## **Proposed Timaru District Plan**

### **Section 42A Report: Energy and Infrastructure, Stormwater and Transport**

**Report on submissions and further submissions**

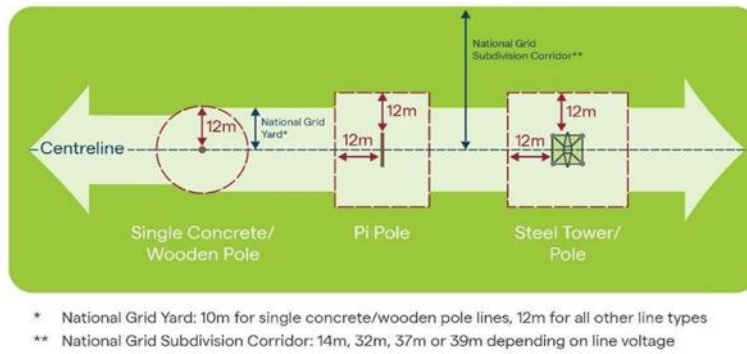
6.7.4 Transpower supports the definition but seeks to replace Diagram 1 with an updated diagram as follows:

- 6.7.8 I recommend that the submission from Transpower [159.10] is **accepted**.
- 6.7.9 I recommend that the submissions from Bruce Spiers [66.3], Rooney, et al [174.7, 191.7, 249.7, 250.7, 251.7, 252.7] and Kāinga Ora [229.3] are **rejected**.
- 6.7.10 Replace the diagram in the definition of “National Grid Subdivision Corridor” with the diagram included in the Transpower submission.
- 6.7.11 In terms of a s32AA assessment, I consider the recommended amendments do not change the meaning of the term and therefore the original s32 continues to be applicable.

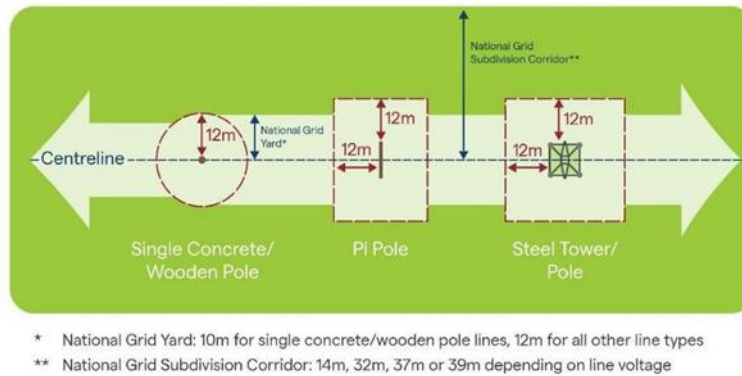
- 6.8.4 Transpower supports the definition of ‘National Grid Yard’ but considers it should be amended to provide for a scenario where a tubular steel tower replaces a lattice tower and to replace Diagram 1 with an updated diagram as follows:

- 6.8.11 Replace the diagram in the definition of “National Grid Yard” with the diagram included in the Transpower submission.
- 6.8.12 In terms of a S32AA assessment, I consider the recommended amendments do not change the meaning of the term and therefore the original s32 continues to be applicable.
